**Addendum to Review of Burnaby Mountain
Tunnel Option
to
City of Burnaby-Engineering Department
No. CoB-01A/14**

Ref: Addendum to “Report on Geotechnical Review of Burnaby Mountain-Tunnel Option” CoB-01/14.

Trans Mountain Pipeline ULC, TMEP Westridge Tunnel Investigation 2014 Site Investigation Data Report – Revision 1 January 23, 2015 Project No.: 0095150-15.

APPENDIX I

Figure 6 INFERRED Q WITH DEPTH – HMM-BH-02

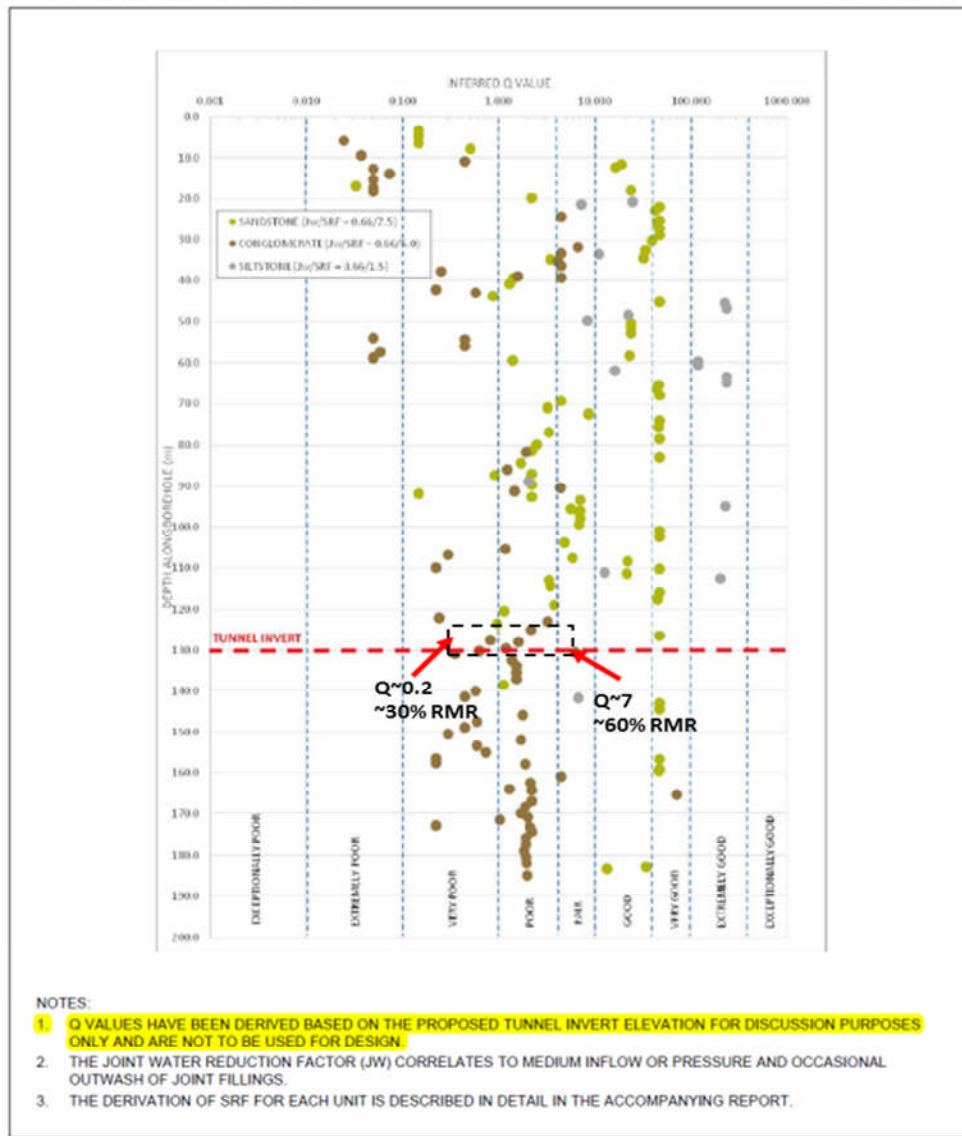
- It must be noted that the recovery of the core from HMM-BH-02 was ~50% and the rock quality ranged from $Q \sim 0.2$ to $Q \sim 7$. This is an approximate equivalent RMR_{76} ($\text{RMR} = 9 \ln Q + 44$) of ~30% to ~60% which is approximately double in magnitude.
- The report states that the "Q values have been derived based on the proposed tunnel invert elevation for discussion purposes only and are not to be used for design". This requires further explanation in terms of its accuracy and usefulness. Note what confidence does the geotechnical consultant have in terms of characterizing the Q/RMR for the 2km of tunnel from a single drill hole?

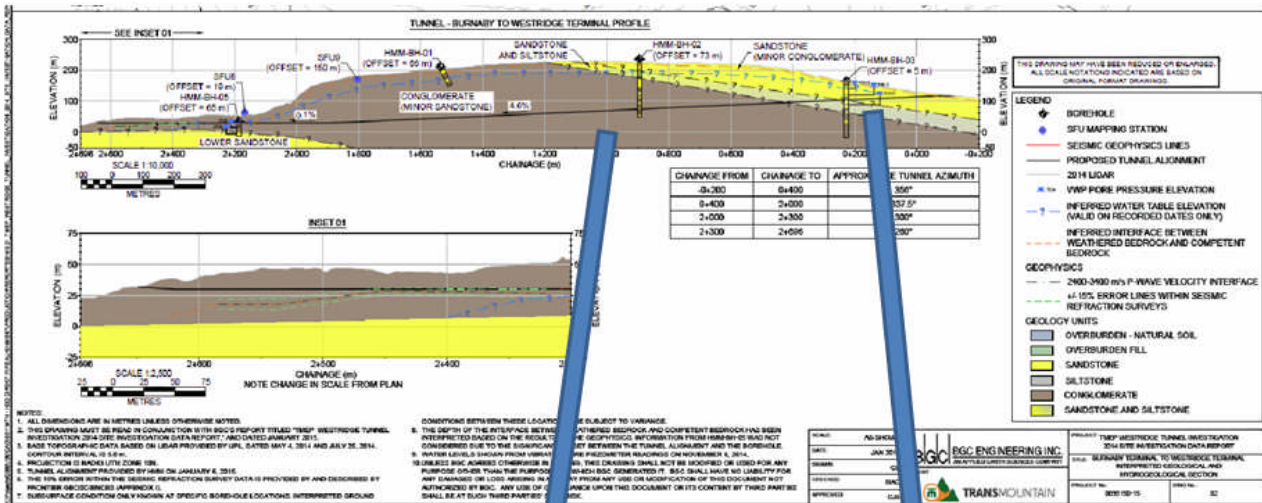
The core logs for HMM-BH-02 show the variability in the rock mass particularly as the TBM will incur primarily conglomerates, however, also sandstones/other units which are variable in rock quality (Q/RMR) and have a direct impact on the performance of the tunnelling machine in terms of potential squeeze/closure/ground Behaviour/support requirements/advance.

Figure 6 INFERRED Q WITH DEPTH – HMM-BH-02

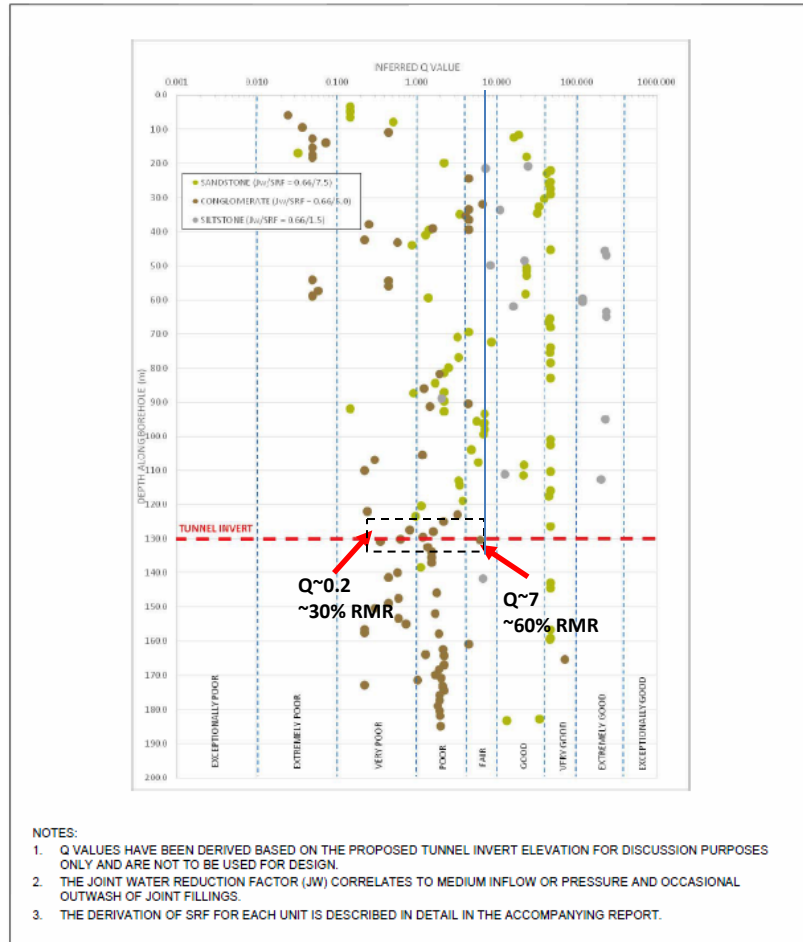
NOTE: USED $\text{RMR} = 9 \ln Q + 44$ TO DETERMINE EQUIVALENCY. NOTE THAT RMR IS RECORDED IN LOGS BUT NOT DISCUSSED IN REPORT. SHOULD CONFIRM.

DRILL HOLE # HMM-BH-02

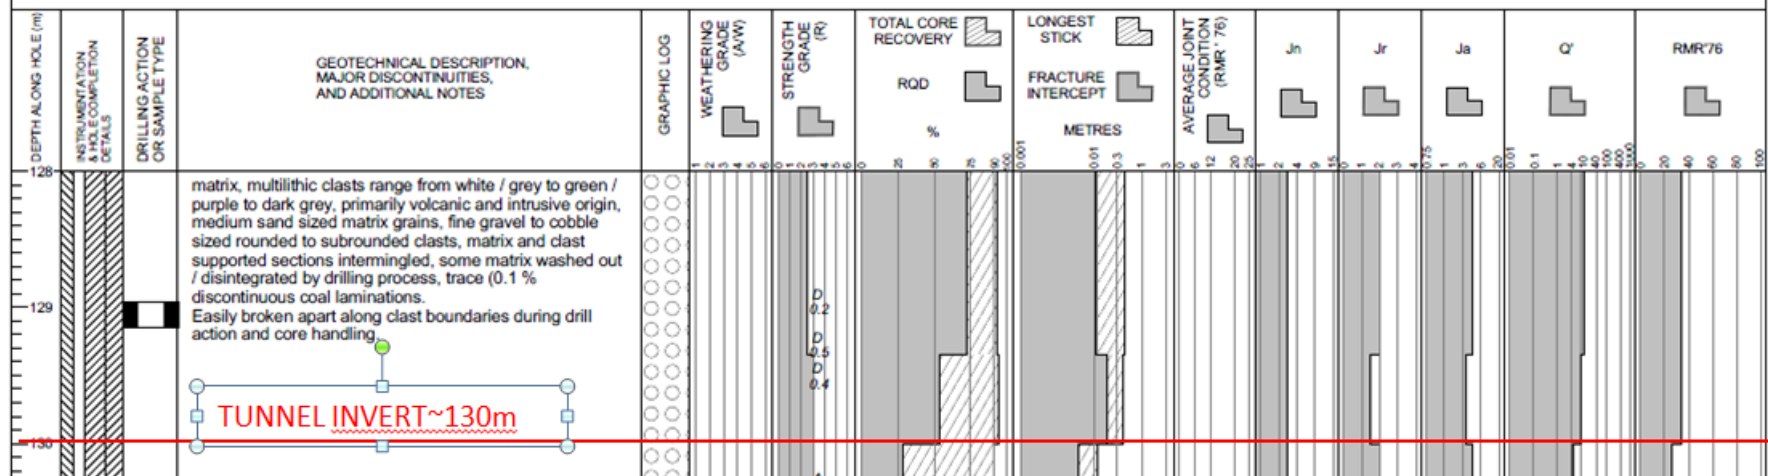
VERY POOR TO POOR

THE VERY POOR HAS RATING FROM $Q=0.1$ RMR~25%-

TO POOR HAS RATING FROM $Q=4.0$ RMR~55%+

THIS IS DRAMATIC DIFFERENCE IN RMR AND RESPONSE TO TBM IN TERMS OF SQUEEZE, CLOSURE, BEHAVIOUR.

NOTE RANGE IS HALF IN TERMS OF RMR.

USED $RMR=9\ln Q + 44$ AS WELL AS FROM LOGS PROVIDED IN APPENDIX (BIENIAWSKI, 1976).

Figure 6 INFERRED Q WITH DEPTH - HMM-BH-02

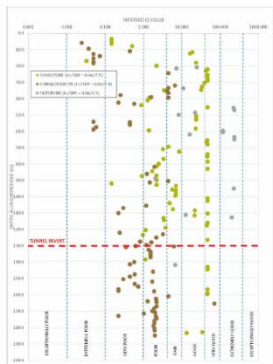
- BH-02 GIVES GREATER VALIDITY AS IS WITHIN THE PROFILE AT INVERT. BUT NOT EVEN CLOSE TO MAKING CONCLUSIONS WITHOUT FURTHER DRILLING/CHARACTERIZATION ALONG THE TUNNEL LINE IN MY PROFESSIONAL OPINION. NOTE NOT TO BE USED FOR DESIGN AS INDICATED BY BGC.

- STILL THE RMR RANGES FROM 30% TO 60% AT THAT SAME ELEVATION. SO SELECT A NUMBER . THE REPORT SEEMS TO SAY ALL BAD WELL HOW DO THEY HANDLE ALL BAD IE. SQUEEZE POTENTIAL/TUNNEL BEHAVIOUR

- HAVE THE POLEPLOT NOW. EXCELLENT. WHY DID WE REVIEW THE INCOMPLETE INFORMATION IN DECEMBER'2014.
- NEED TO KNOW ACTUAL ELEVATION OF INVERT. NOTE ONLY ON FIGURE 5,6,7,8

- SEE BELOW – QUESTIONS VALID AS INDICATED.
- LOOKS LIKE FURTHER HOLES ARE PLANNED PRIOR TO EXCAVATION. THIS IS WHAT IS REQUIRED AS AT THIS STAGE THE INFORMATION IS LARGELY A POINT SOURCE FOR ~2KM OF TUNNEL. QUESTION: WOULD THIS BE SUFFICIENT FOR A TUNNELING CONTRACTOR TO BID ON IN TERMS OF THE TUNNEL CHARACTERIZATION.
